3 WS - 76 Yates Mill Dr., Fuquay - Varina, NC 27526

The Apex - RH
'CRAFTSMAN'

2-14-24 Initial Redlines- JJ

ARCHITECTURAL DRAWINGS

FIRST FLOOR PLAN 'CRAFTSMAN'

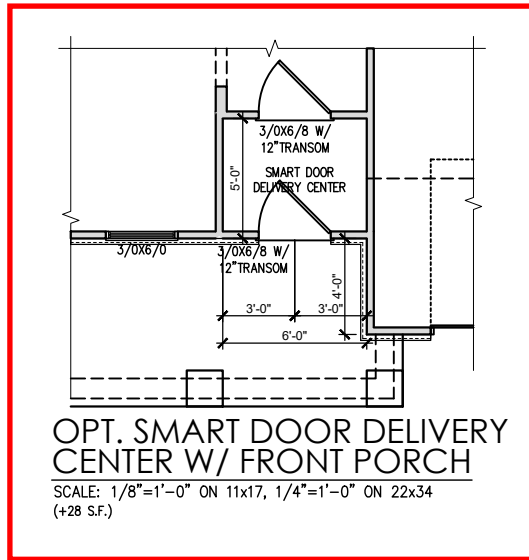
Install a 60"x34" fiberglass shower

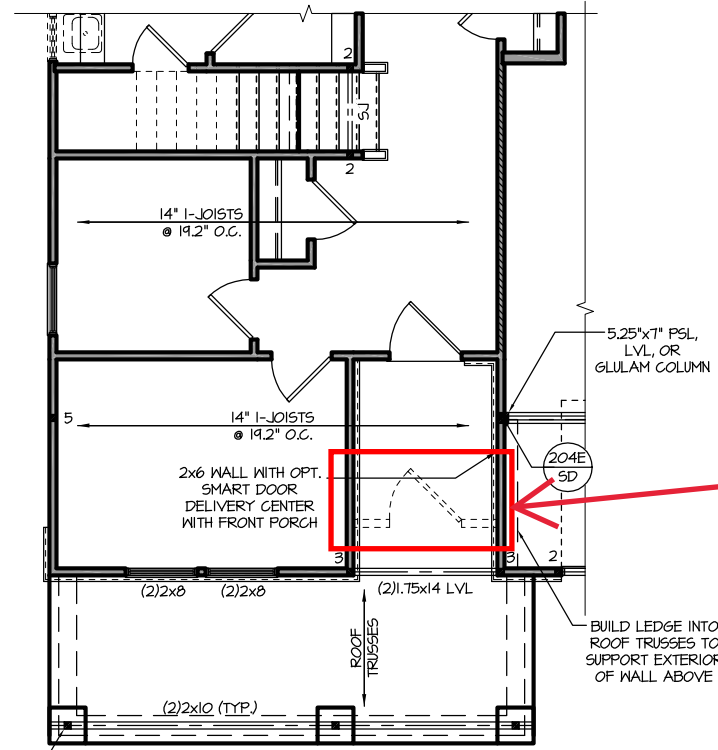
Install 60"x34" fiberglass shower
